Outer Dowsing Offshore Wind

The Applicant's Responses to The ExA's First Written Questions (ExQ1)

Document Reference: 19.2

Appendix 1.14 Q1 LU 1.2 ALC Plan and Table

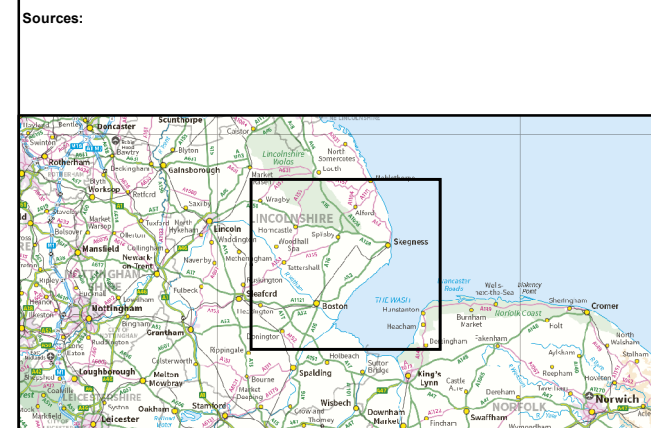
Q1 LU 1.2	The Applicant	<p>Onshore Export Cable Corridor (ECC) alternatives - Agricultural Land Classification (ALC)</p> <p>Table 1 of the Erratum to Site Selection and Consideration of Alternatives [PD1-074] provides updated information to compare the provisional ALC for ECC options 1, 2 and 3 with cross reference to Figure 4.20 [APP-090]. However, the ExA notes that from the Applicant’s response to the Relevant Representation [PD1-071] from TH Clements & Sons Ltd that “<i>...the route options presented in Figure 4.20 are a set of initial routes, which have been subject to further refinement. The key outcome of this consultation was the diversion of Option 1 to the north and west of the A52 (away from the very top-quality silty soils situated to the east of the A52 public highway, as suggested by TH Clements & Sons), which resulted in a significant reduction in the areas of Grade 1 ALC land being crossed by the final route.</i>”</p> <ul style="list-style-type: none"> ▪ Please provide a clear plan that identifies the final onshore ECC route alongside all alternatives considered. ▪ For each route identified on the plan, provide a table that clearly identifies the amount of provisional ALC by grade, in Hectares for each option. 	<p>Figure 1.14 Q1 LU 1.2 provides a clear plan of the 10 initial routes that were considered when undertaking the route selection for the ECC.</p> <p>Table 1.14 Q1 LU 1.2 provides the amount of ALC by grade for each of these initial routes, which assumed a uniform route width of 200m. This 200m was the width of the search route areas which were being considered at that time, which allowed for future refinement to the 80m corridor proposed in the application.</p> <p>In addition to responding directly to the factual request made by the ExA, the Applicant has also taken the opportunity to address the related concern raised by T.H. Clements in their Relevant Representation, that the Applicant did not apply weighting to the individual ALC Grades.</p> <p>To test the significance and implications of that concern, the Applicant has undertaken an exercise whereby it applied a weighting to each ALC Grade and ranked the route options based solely on the weighted results relating to ALC Grade. As can be seen from Table 1.14 Q1 LU 1.2, the option preferred by T.H. Clements, which goes around the north of Boston, comes 6th out of the 10 assessed using this approach, whereas the chosen route is ranked 2nd.</p> <p>The plan in Figure 1.14 Q1 LU 1.2 shows that the route which ranks 1st on this ‘ALC only’ approach was not chosen, although it is almost identical to the chosen route, except for an area of Grade 3 land near Thorpe St Peter, due to the higher number of residential receptors that could be affected and a significantly more complex engineering crossing of the Steeping River and Railway which would result in greater impacts and therefore constitute a less desirable option overall. This serves to illustrate the point that route</p>

Appendix 1.19 Q1 OG 1.3 Other Offshore Infrastructure Figure

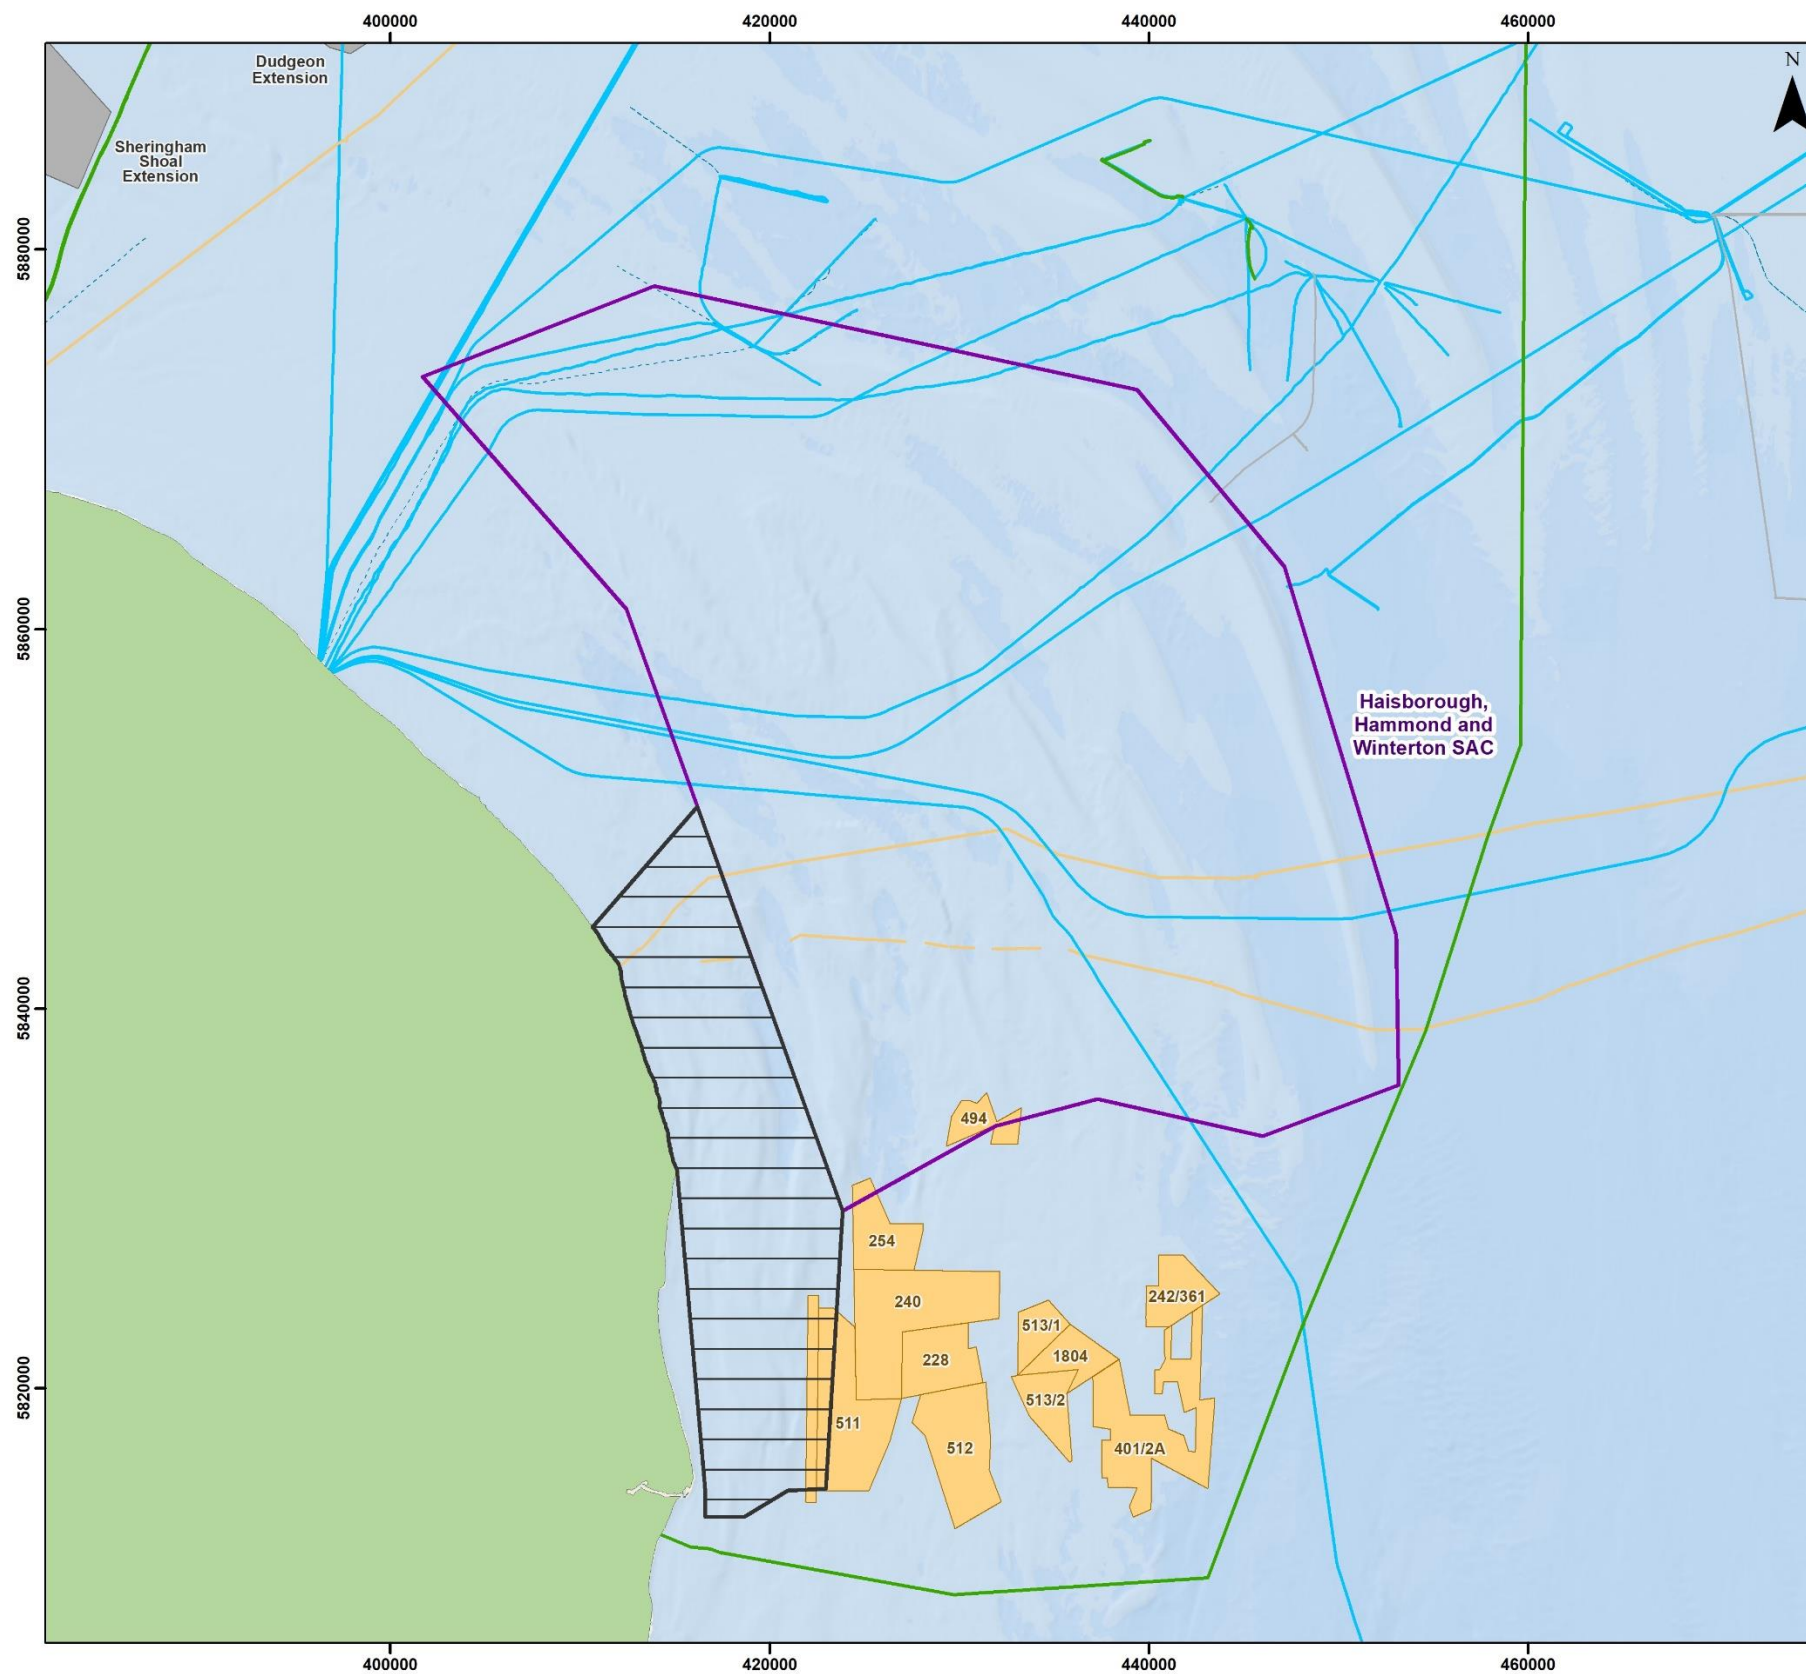
Q1 OG 1.3	The Applicant Diamond Transmission Partners RB Limited	Impacts on other offshore infrastructure arising from the potential extension of Special Areas of Conservation (SACs) Concerns have been raised by Diamond Transmission Partners RB Limited	The Applicant confirms that the active subsea power cable identified in Paragraph 80 is an error and should refer to cable (not in use). The two cables shown in figure 3.6 as being within the SAC extension area are decommissioned telecommunication cables: <ul style="list-style-type: none"> ▪ VODAFONE AND KPN between the UK and the Netherland, and
